PRAIRIE ISLAND NUCLEAR GENERATING PLANT
UNITS 1 AND 2

Improved Technical Specifications
Conversion Submittal

PACKAGE 1.0

USE AND APPLICATION

Figure 2.1.1-1 (page 1 of 1)
Reactor Core Safety Limits

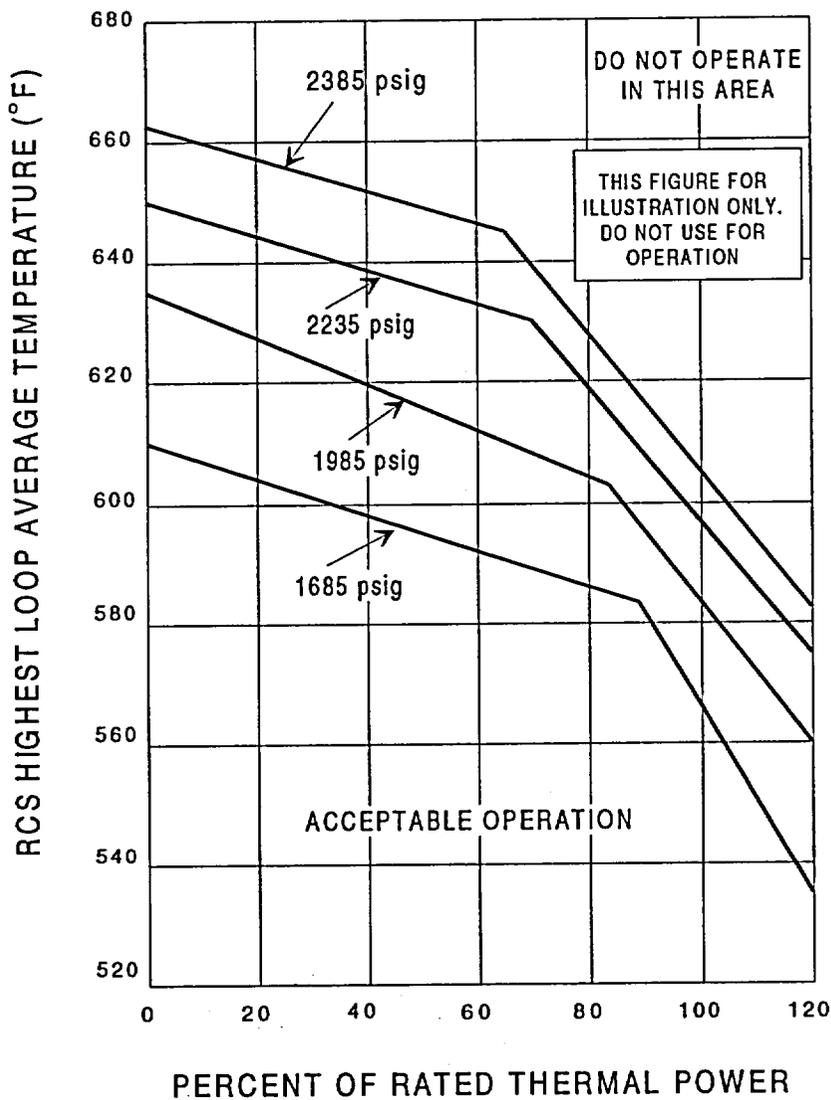
Replace with CTS Figure TS-2.1.1

CL2.0-13

Figure B 2.1.1-1 (page 1 of 1)
Reactor Core Safety Limits vs. Boundary of Protection

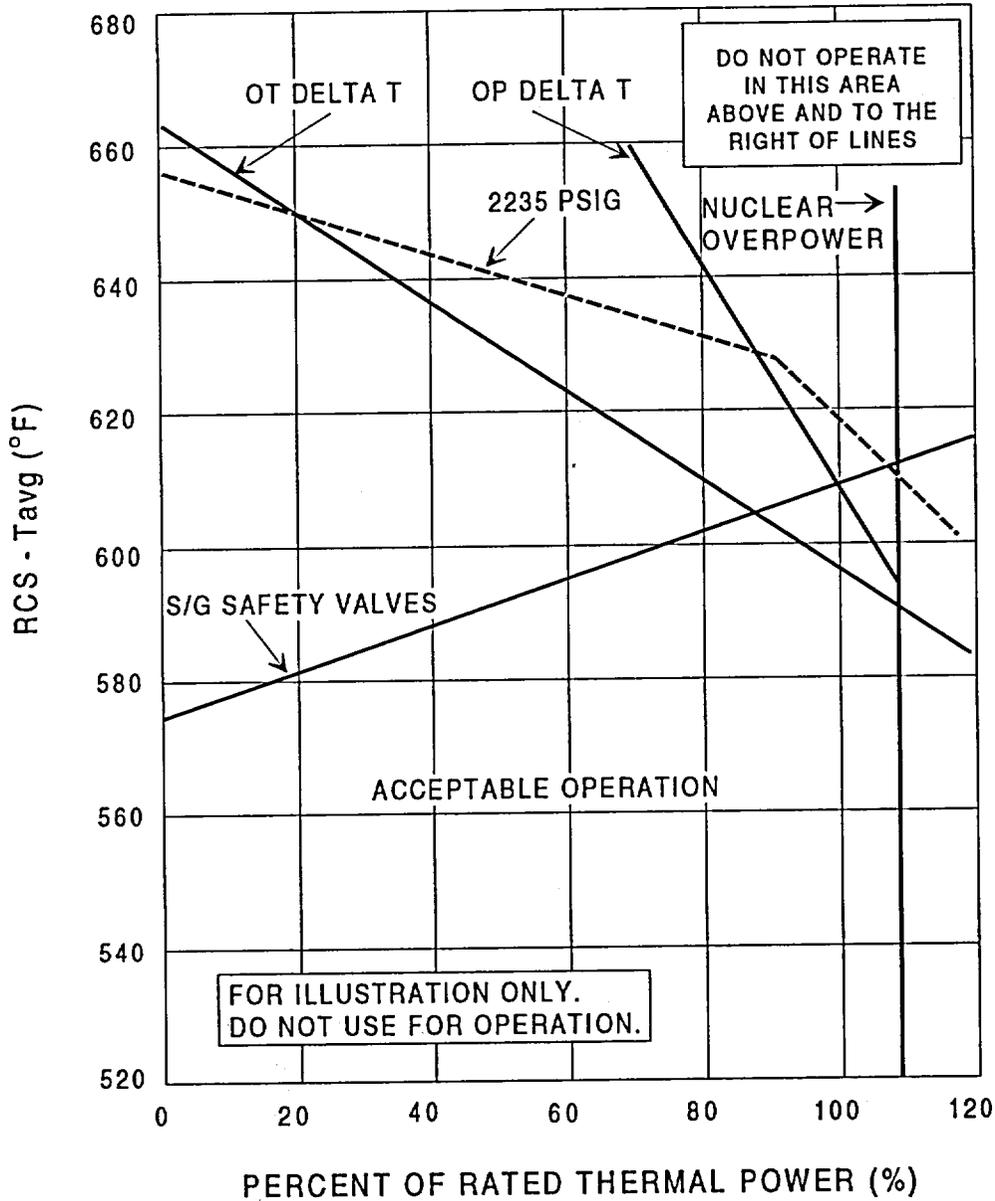
Replace this Figure with CTS Figure B2.1.1

CL2.0-33
